CHANGES AS SUBMITTED IN S4.55 -
UNDER REVIEW - MOD/2024/0225

1728 Fortis South Steyne

34-35 South Steyne Manly NSW

Section E 1:00

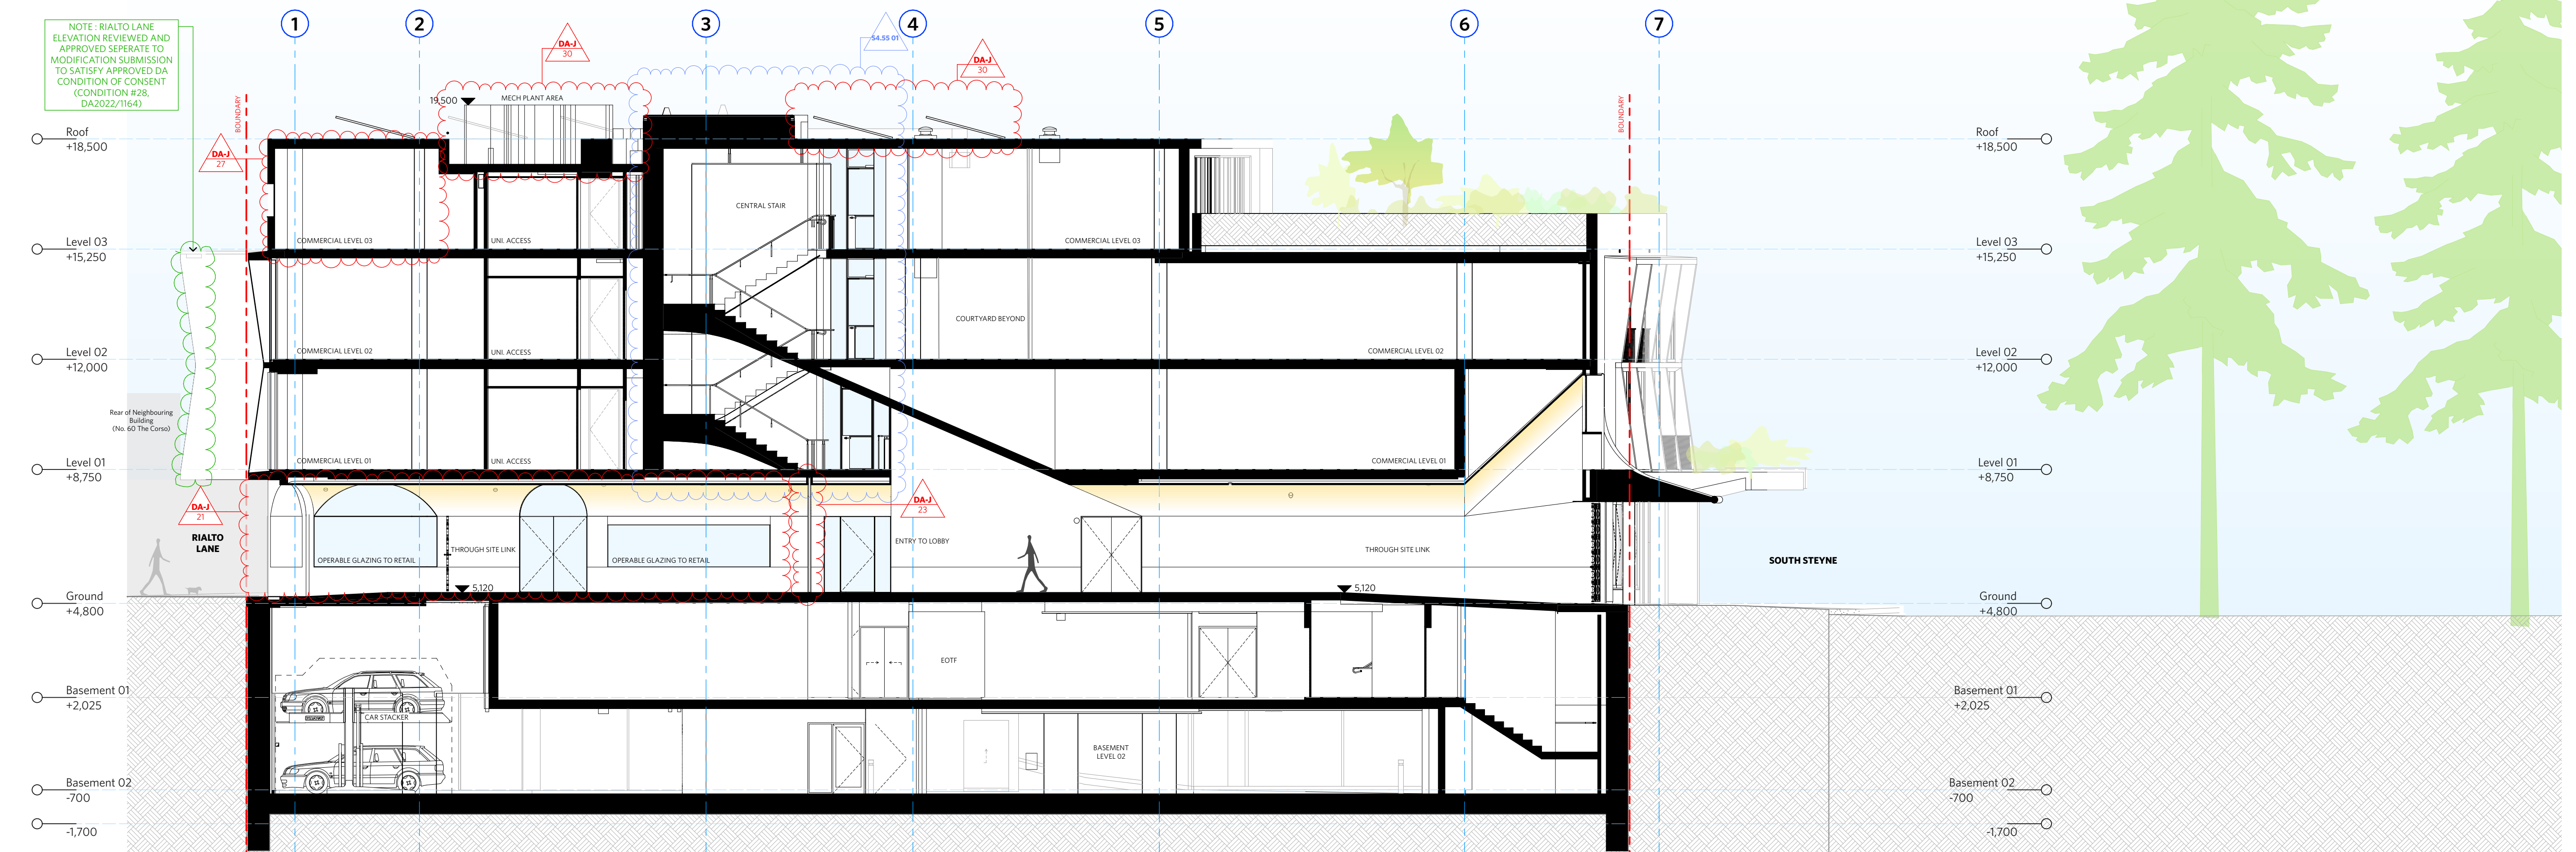
REV	CHANGE	DESCRIPTION
	17	Amendments to Central Stair
	21	Additional openings added into Ground Floor Tenancy
	23	Sliding Fire Door Added to Through Site Link
A-1	25	Changes to the Central Courtyard
	27	Increase in Floor Space to the west
	28	Changes to the Amenities to suit revised floor plate
	30	Revised Roof Layout to suit new form, including Revised Mechanical, Solar & other Equipment

Section DD

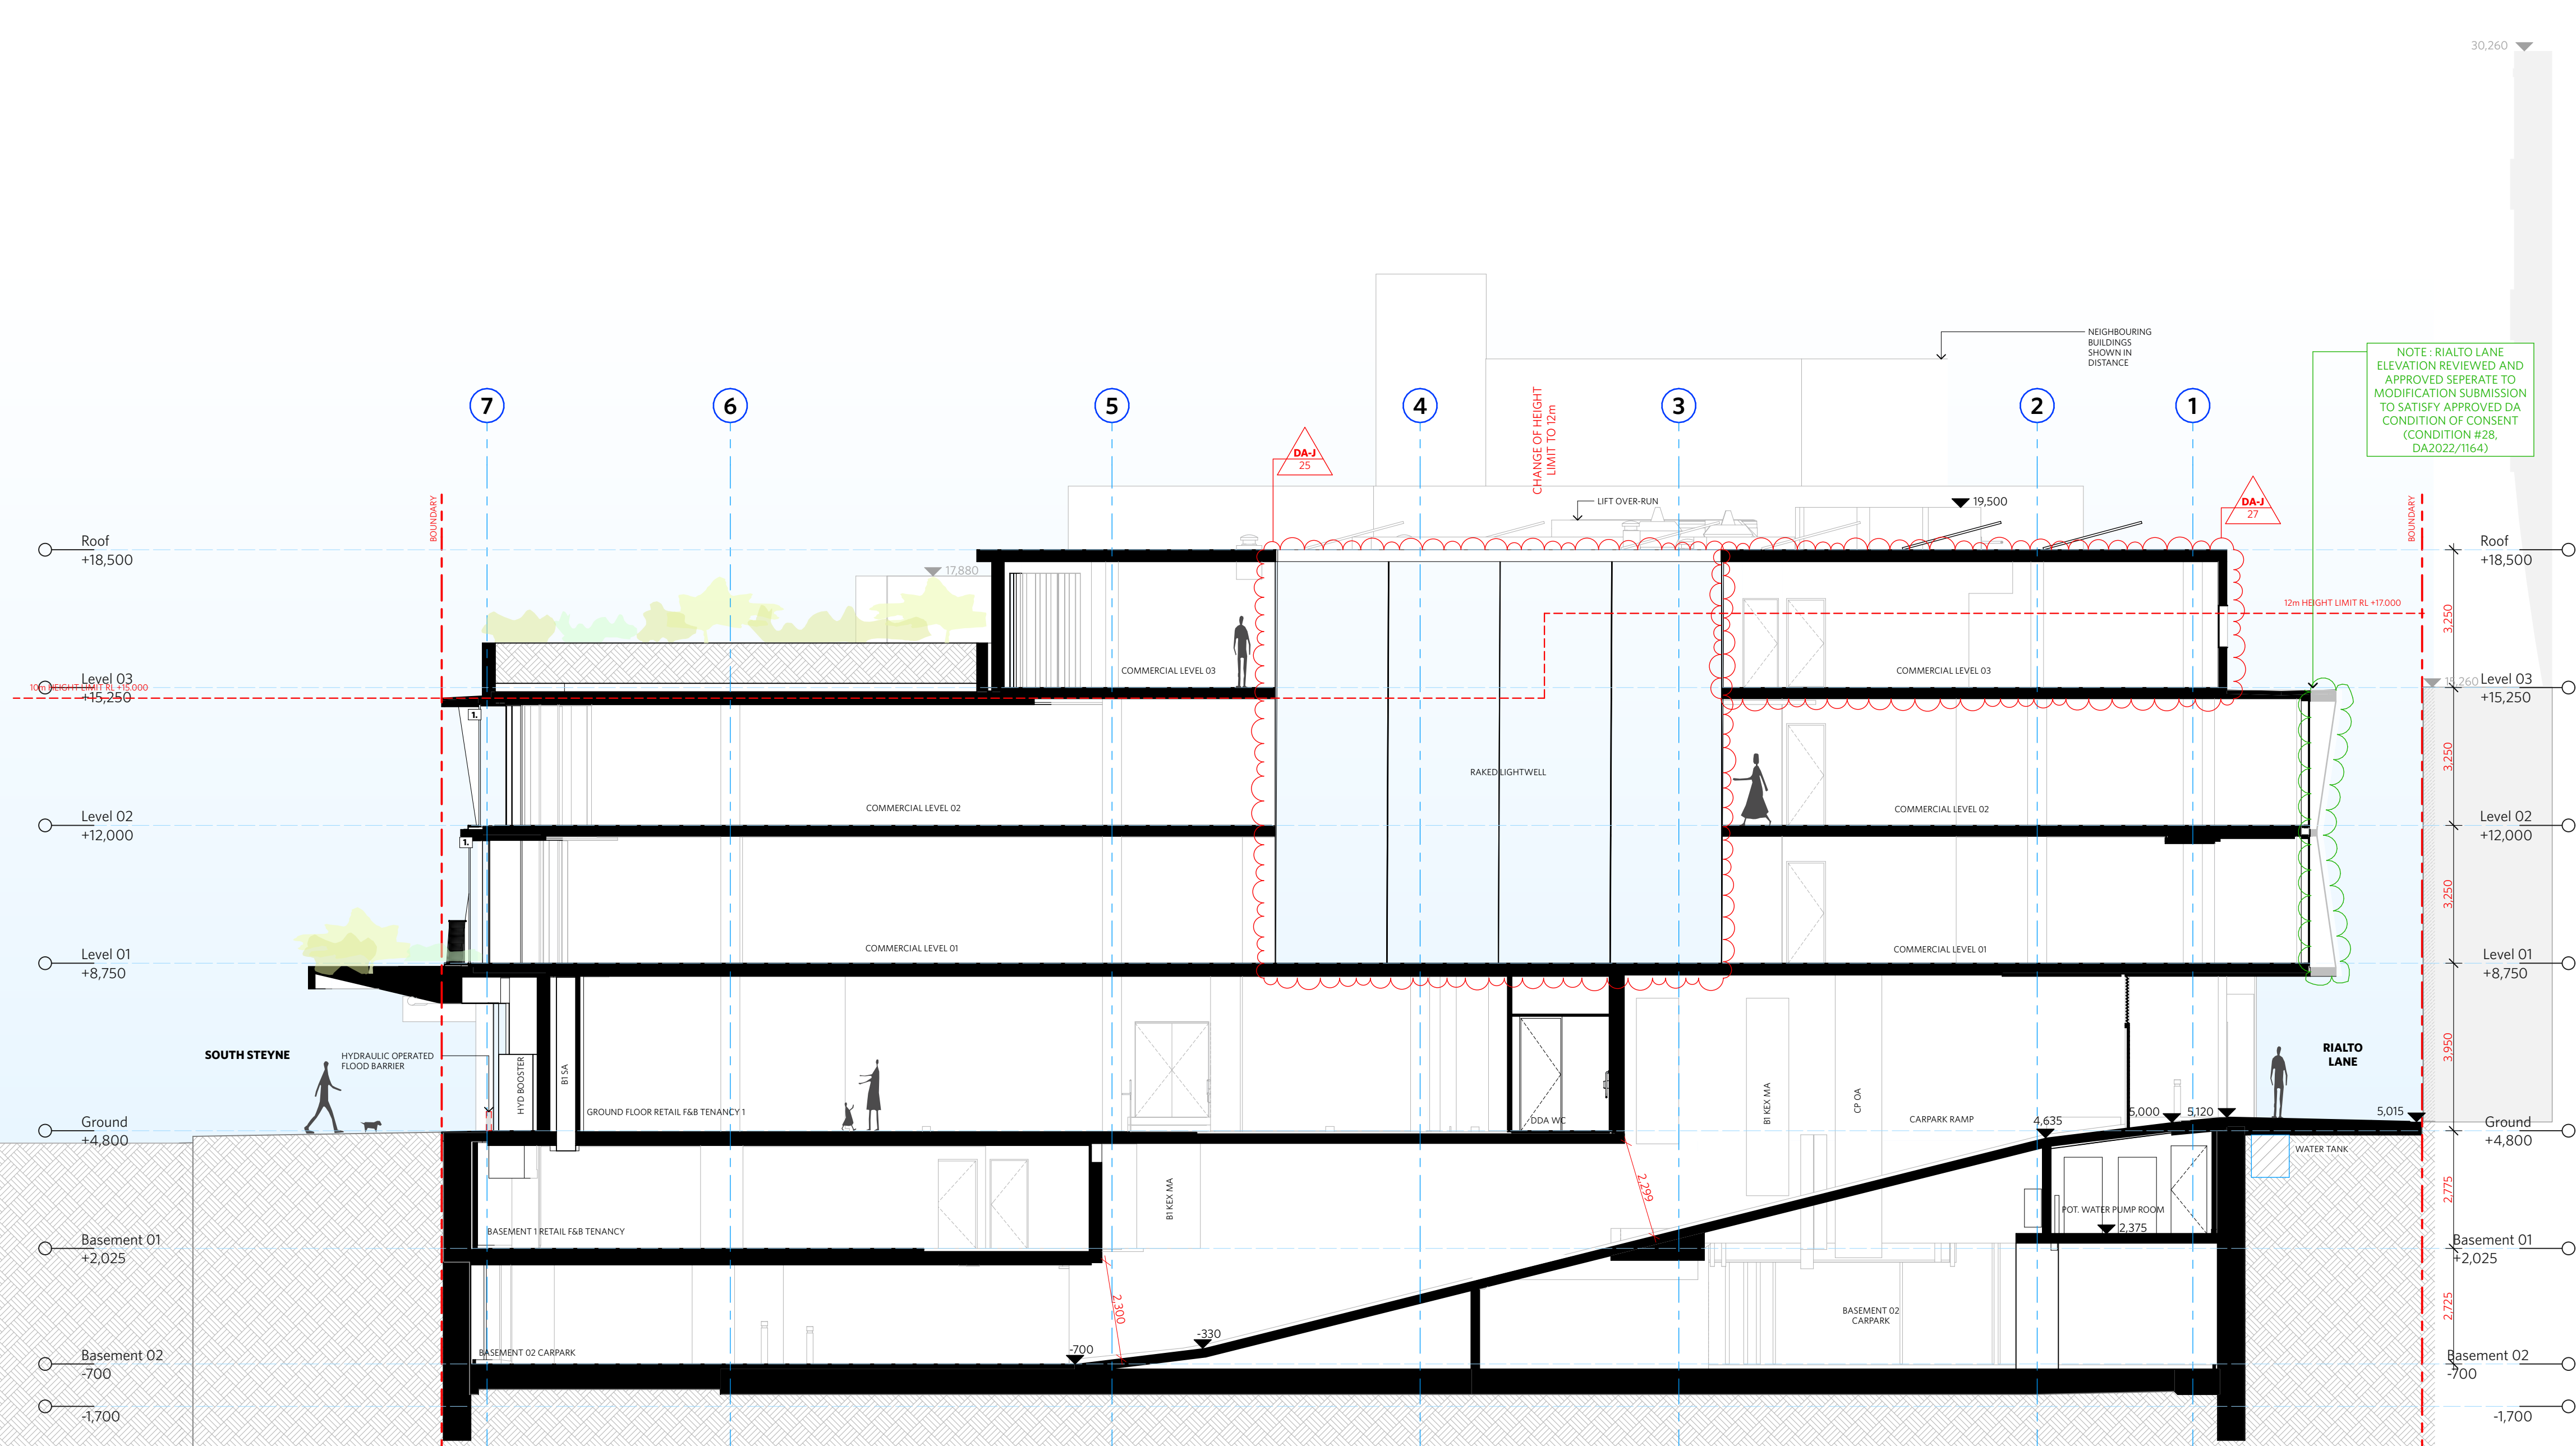
CHANGE SUMMARY		
REV	CHANGE	DESCRIPTION
DA-J	27	Increase in Floor Space to the west
	28	Changes to the Amenities to suit revised floor plate
	30	Revised Roof Layout to suit new form, including Revised Mechanical Solar & other Equipment
